SUBJECT: VIRGINIA ELECTRIC AND POWER COMPANY, North Anna Power Station,
Unit Nos. 1 and 2

AMENDMENT TO FACILITY OPERATING LICENSE

Amendment No. 37
License No. NPF-4

ATTACHMENT TO LICENSE AMENDMENT

Figure 3.2-1 Axial Flux Difference Limits as a Function of Rated Thermal Power

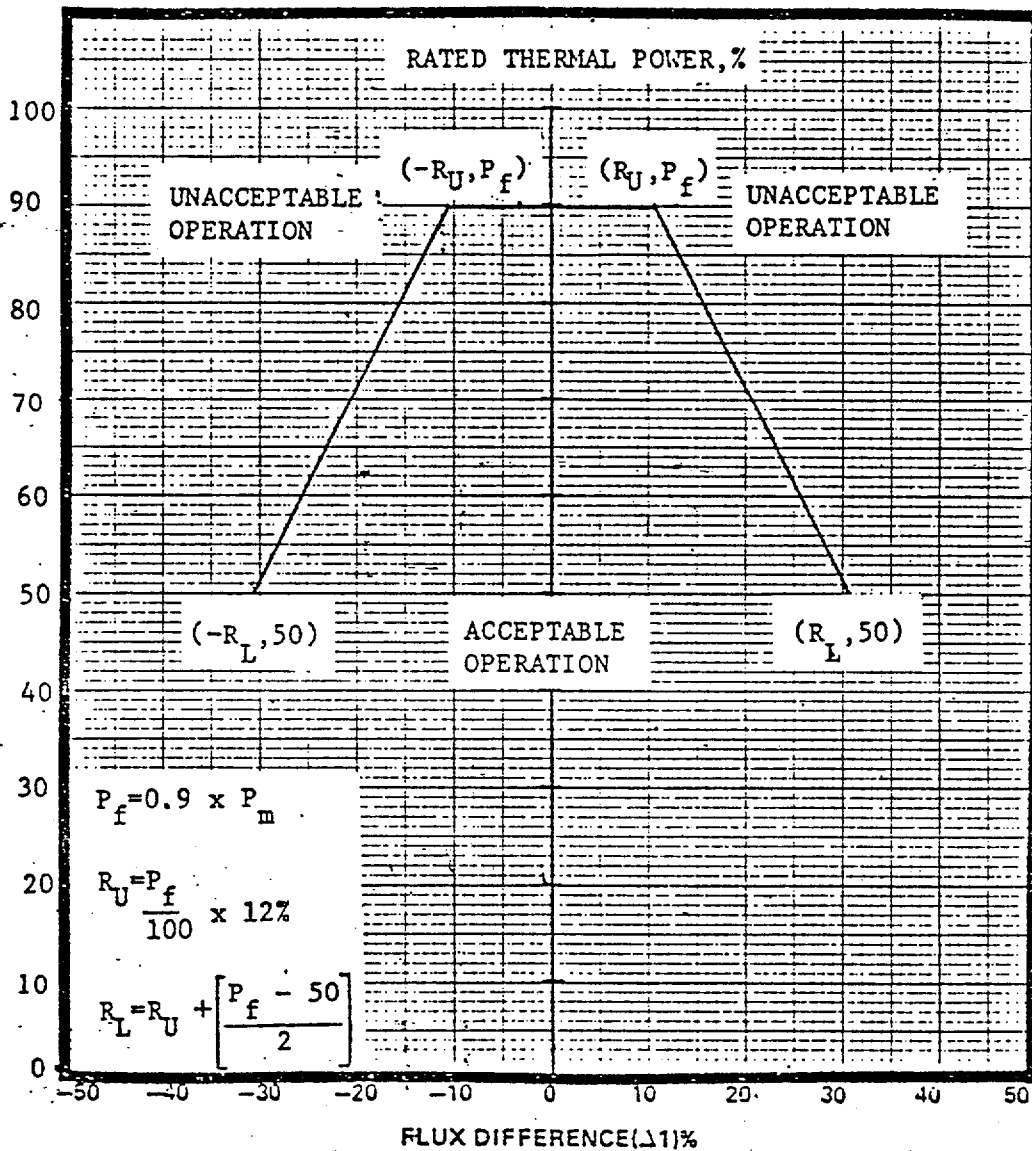
- a. With the indicated AXIAL FLUX DIFFERENCE outside of the $\pm 5\%$ target band about the target flux difference and with THERMAL POWER:
 1. Above $P_f\%$ of RATED THERMAL POWER, within 15 minutes, where $P_f = (0.9 \times P_m)$; the value for P_m is established in the Core Surveillance Report per Technical Specification 6.9.1.10.

- a) Either restore the indicated AFD to within the target band limits, or
 - b). Reduce THERMAL POWER to less than $P_f\%$ of RATED THERMAL POWER.
 2. Between 50% and $P_f\%$ of RATED THERMAL POWER:

- 2) The indicated AFD is within the limits shown on Figure 3.2-1. Otherwise, reduce THERMAL POWER to less than 50% of RATED THERMAL POWER within 30 minutes and reduce the Power Range Neutron Flux-High Trip Setpoints to less than or equal to 55% of RATED THERMAL POWER within the next 4 hours.

The proposed changes require that several NA-1&2 TS be modified where the parameters F_{xy} , P_m , and a Figure 3.2-1 (a curve which is a function of P_m) are specified. All of these changes have been reviewed and are acceptable.

Figure 3.2-1 Axial Flux Difference Limits as a Function of Rated Thermal Power

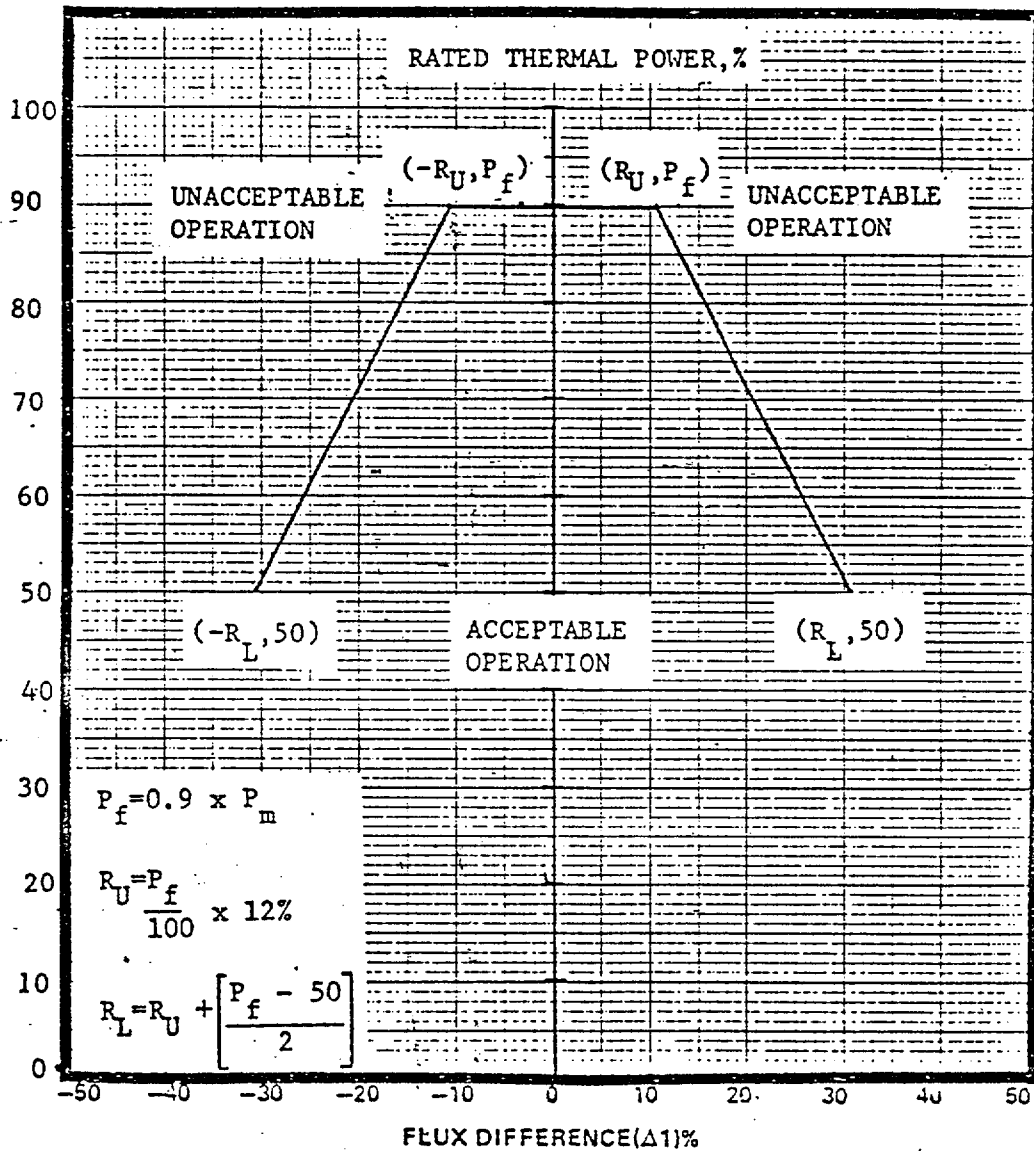
- 2) The indicated AFD is within the limits shown on Figure 3.2-1. Otherwise, reduce THERMAL POWER to less than 50% of RATED THERMAL POWER within 30 minutes and reduce the Power Range Neutron Flux-High Trip Setpoints to less than or equal to 55% of RATED THERMAL POWER within the next 4 hours.
